SUNDRY NOTICES AND REPORTS ON WELLS

Jones Canyon 4 Federal #9 API#: 30-015-32622 Lease #: NMNM83037

Jones Canyon 4 Federal #9 30-015-32622 Oxy USA WTP Limited Partnership July 13, 2011 Conditions of Approval

Proposed

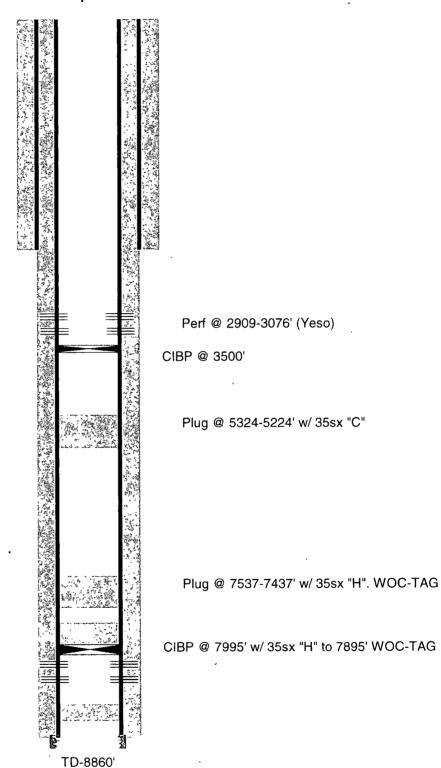
- 1. Contact BLM 575-393-3612 (Lea County) or 575-361-2822 (Eddy County) a minimum of 4 hours prior to setting CIBP above Cisco.
- 2. Surface disturbance beyond the originally approved pad must have prior approval.
- 3. Closed loop system required. File Form C-144 W/NMOCD
- 4. Operator to have H2S monitoring equipment on location as H2S has been reported from wells in the area.
- 5. Subsequent sundry with completion report and wellbore schematic required.
